UNITED STATES PATENT AND TRADEMARK OFFICE

APPLICATION NO.	FILING DATE	FIRST NAMED INVENTOR	ATTORNEY DOCKET NO.	CONFIRMATION NO.
10/586,386	10/02/2006	Gunther Leising	00366.000214	1805

Office Action Summary

DETAILED ACTION

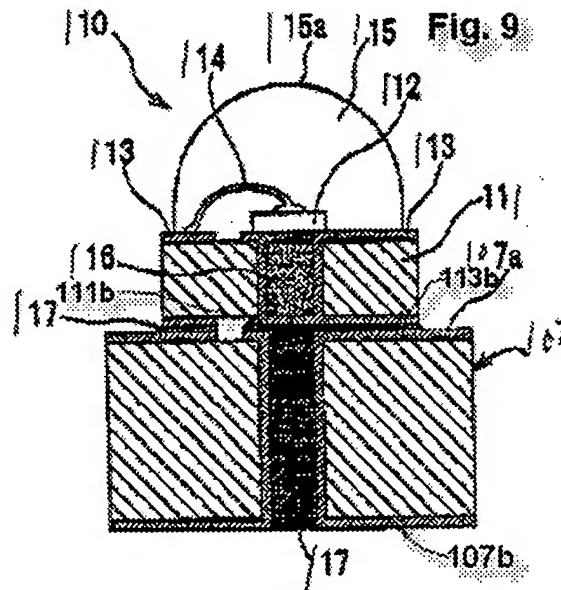
As for claim 1, Suehiro et al. shows (Fig. 2A; [0079]; [0085]) a light emitting diode 11, wherein at least one light emitting diode die 2 is arranged on a light emitting diode printed circuit board 3 with a die attach and the light emitting diode printed circuit board 3 has, on the side 3b opposite to the light emitting diode die 2, rear side contacts 4b which if appropriate are formed as plug contacts, wherein the rear side contacts 4b cover over at least half the area, preferably the entire area apart from the necessary exceptions, of the light emitting diode printed circuit board 3.

As for claim 2, the rear side contacts 4b are thermally, and if appropriate electrically, connected with the contact areas on the side of the light emitting diode
